Summary of Comments on Serial Attached SCSI 1.1 (SAS-1.1) Standard

Figure 93 — TCTF test load

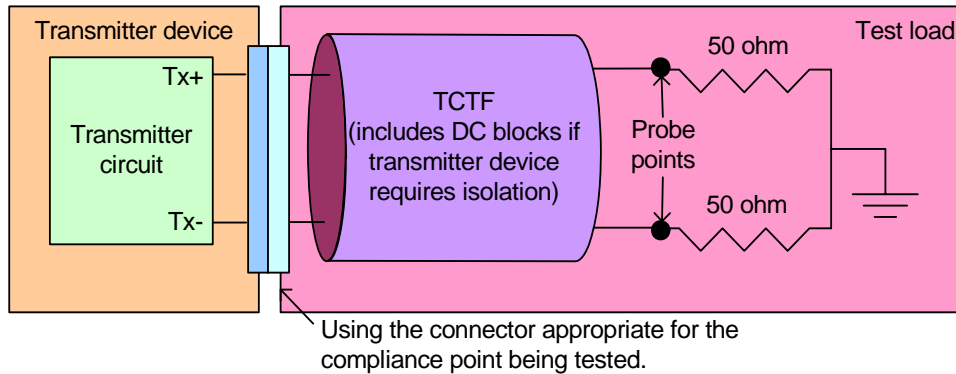
The TCTF test load shall meet the ¹media requirements in table 30 (see 5.2.6). The nominal impedance shall be the target impedance. ²

Sequence number: 1
Author: coxa
Subject: Cross-Out
Date: 5/8/2005 9:54:01 PM

Sequence number: 2
Author: coxa
Subject: Inserted Text
Date: 5/8/2005 9:54:08 PM

impedance

Figure 96 — Low-loss TCTF test load

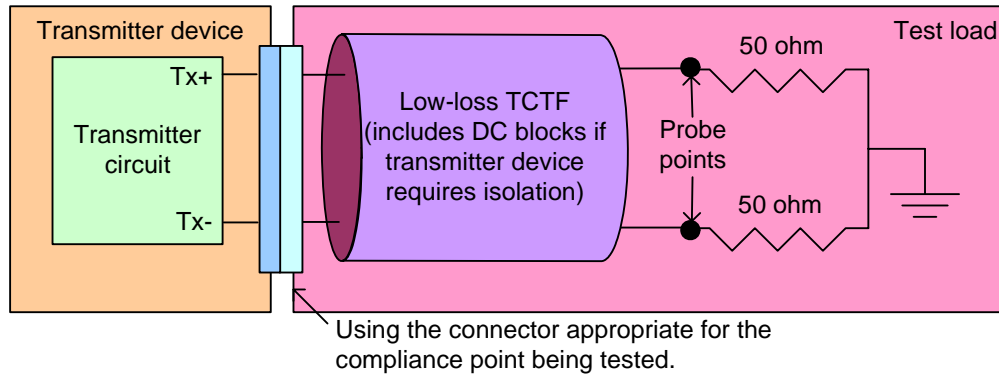
The low-loss TCTF test load shall meet the ¹media requirements for internal cables and backplanes in table 30 (see 5.2.6). The nominal impedance shall be the ²target impedance.

Sequence number: 1
Author: coxa
Subject: Cross-Out
Date: 5/8/2005 9:54:30 PM

Sequence number: 2
Author: coxa
Subject: Inserted Text
Date: 5/8/2005 9:54:35 PM

impedance
